PLANNED UNIT DEVELOPMENT,
SUBDIVISION &
SIDEWALK WAIVER REQUEST
STAFF REPORT

Date: June 21, 2007

<u>NAME</u>	The Pines at the Preserve LLC
<u>SUBDIVISION NAME</u>	Longleaf Gates Subdivision
<u>LOCATION</u>	North side of Girby Road, 1800'± West of Rue Preserve, and extending Northwest to Lloyds Lane
<u>CITY COUNCIL DISTRICT</u>	District 6
<u>PRESENT ZONING</u>	R-2, Two-Family Residential District
<u>AREA OF PROPERTY</u>	159 Lot / 84.2 ± Acres
<u>CONTEMPLATED USE</u>	<i>Planned Unit Development</i> approval to allow a private street, gated subdivision, and a public street subdivision, both with reduced lot sizes, reduced front yard and side yard setbacks, and increased site coverage, <i>Subdivision</i> approval to create 159-lots, and <i>Sidewalk Waiver</i> approval to waive construction of sidewalks along Girby Road and Lloyds Lane.
<u>TIME SCHEDULE FOR DEVELOPMENT</u>	<i>Phase One:</i> immediate, with completion by October 2008 <i>Phase Two:</i> schedule to be determined after Phase One is completed

SITE PLAN

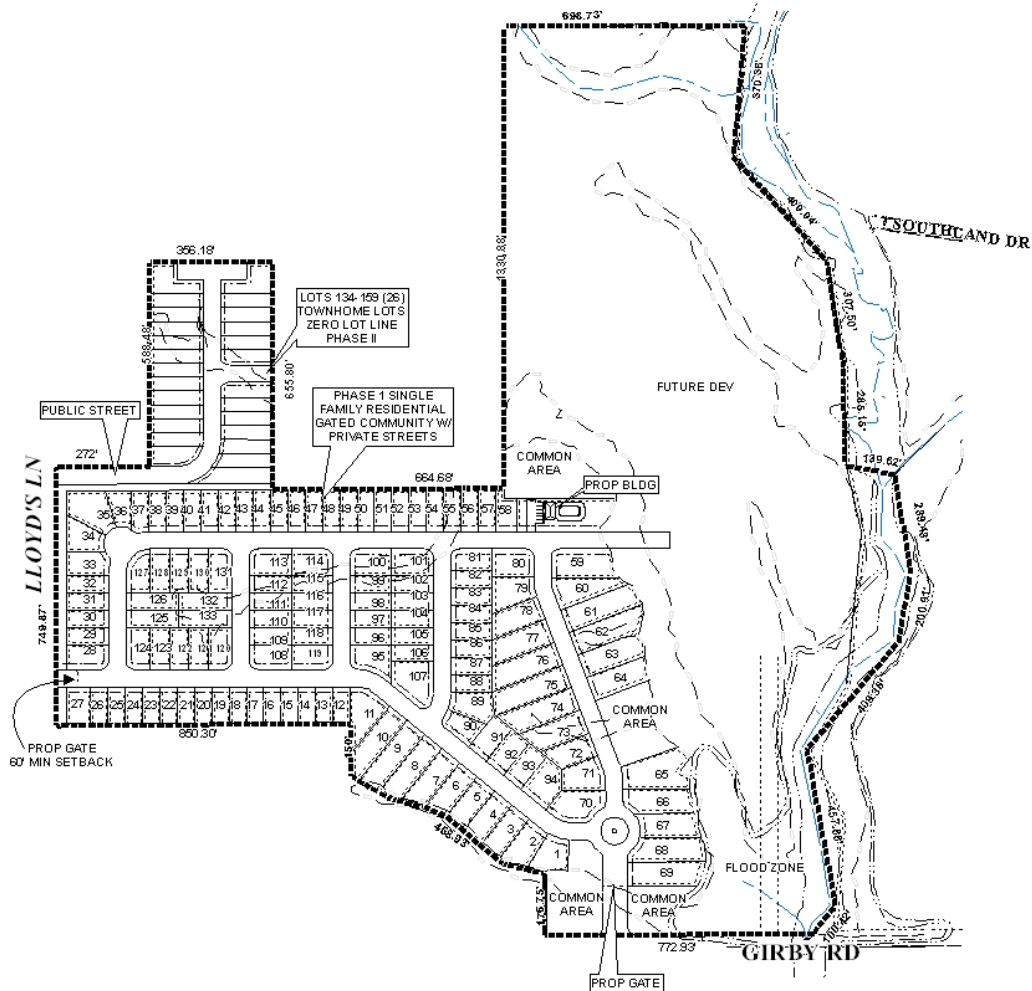
Distinguish more clearly between public and private right-of-way.

It appears that the plat and site plan do not include the full extent of the parcels set aside for "future development," thus the drawings should be revised to account for the entirety of all parcels. It also appears that the parcels comprising the "future development" area are split-zoned, thus rezoning applications should be included with future applications to develop the area.

Common areas are depicted on the site plan. Some of the common areas include storm water detention facilities which will be shared between the Phase One and Phase Two developments. A “pigeonaire/guard house” is also proposed at the center of a traffic circle, however, the area is not labeled as a common area. The site plan and plat should be revised to label all common areas, and a note should be placed on the site plan and plat stating that maintenance of the common areas shall be the responsibility of the property owners.

Due to the size of the proposed development, it is requested that the applicant revise the plat and site plan to provide the size of each lot in square feet on the plat, either as a table or as a label for each individual lot.

- 1) revision of the site plan to encompass the entirety of the parcels associated with the “future development” area;
- 2) submission of applications to correct split-zoning conditions in the “future development” area in conjunction with the other future applications that will be required for the area;

- 3) revision of the site plan to delineate common area in acres by phases, and overall total;
- 4) revision of the site plan to label all common areas, and placement of a note on the site plan stating that maintenance of the common areas is the responsibility of the homeowners (association);

- 5) placement of a note on the site plan identifying which streets are private, and that they are privately maintained and not dedicated to the public;

- 6) placement of a note on the site plan stating that additional street-stub connections will be required in the “future development area” – to adjacent public streets and landlocked properties;

- 7) placement of a note on the site plan and plat stating that direct access to Girby Road and Lloyd’s Lane is denied for all lots and common areas, and each lot (and common area if required for maintenance purposes) should be limited to one curb-cut each, with the size, design and location to be approved by Traffic Engineering and comply with AASHTO standards;

- 10) labeling of all lots with size in square feet, or provision of a table with the lot size information on the plat;
- 11) provision of a revised PUD site plan to the Planning Section of Urban Development prior to the signing of the final plat; and
- 12) that the applicant obtain all necessary federal, state and local permits.
